January 9, 2019

RE: NRDC et al. Comments on Energy Department's Request for Public Comment on the Interpretation of High-Level Radioactive Waste

Figure S-16. Lifetime Radiological Risk for the Drinking-Water Well User at the Core Zone Boundary due to Releases from the Six Sets of Cribs and Trenches (Ditches)

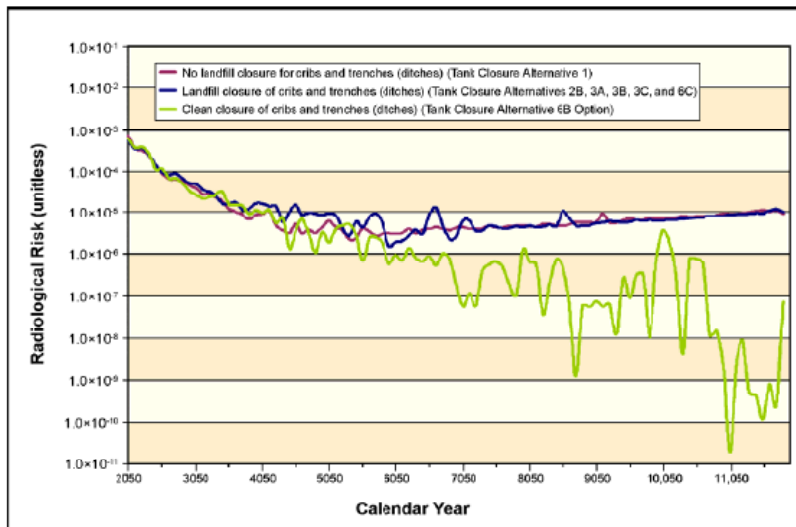
Figure S-16 shows long-term radiological risk from releases from cribs and trenches. Clean closure of cribs (Alternative 6B, light green trace in the figure) includes removal of the contamination sources in the vadose zone. The long-term radiological risk shown on the plot, reflects conditions resulting from an absence of groundwater cleanup. This supports the contention on page S-92 that “Cribs and trenches are major contributors to potential long-term groundwater impacts for all Tank Closure alternatives due to early discharges ...” That is exceptionally true if the groundwater is not cleaned up under the clean close scenario and one drags this groundwater contamination into the risk model that is used to represent a clean closure scenario.

On page S-96 it states that Figures S-16 and S-17 show that clean closure would provide little reduction in long-term impacts to groundwater before CY6000 due to past leaks and cribs and trenches. This is only true because their clean closure scenario is not a clean closure. Under Alt 6A&B with option, the groundwater contamination from past leaks is not remediated and is included in the clean close alternative risk calculation creating substantial risk. As a result, when you compare the relative risks, there is little reduction in long-term impacts to groundwater resulting in the false conclusion of the true benefit of an actual clean closure scenario.

Figures S-16 and S-17 are terribly misleading without a clear explanation of what contamination is and is not represented in the radiological risk determination. DOE's argument of only incremental decrease in radiological risk with clean closure is not a valid argument when comparing it against the risk from an alternative that includes cleanup of the groundwater during and following the retrieval period.
